TYPICAL ADA FIXTURE MOUNTING HEIGHTS (BLOCKING ONLY IN BATHROOMS WHERE SHOWN IN ELEVATIONS)

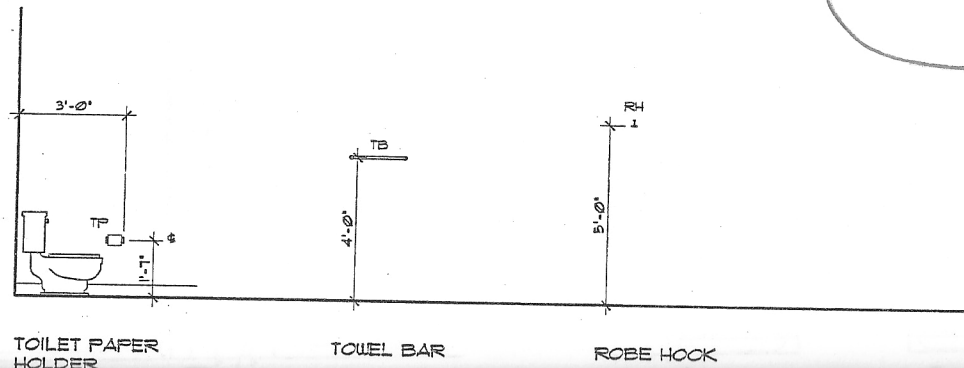
It is likely there is NO BACKING AT BATH TYPE C SINCE IT IS NOT ADAPTABLE.
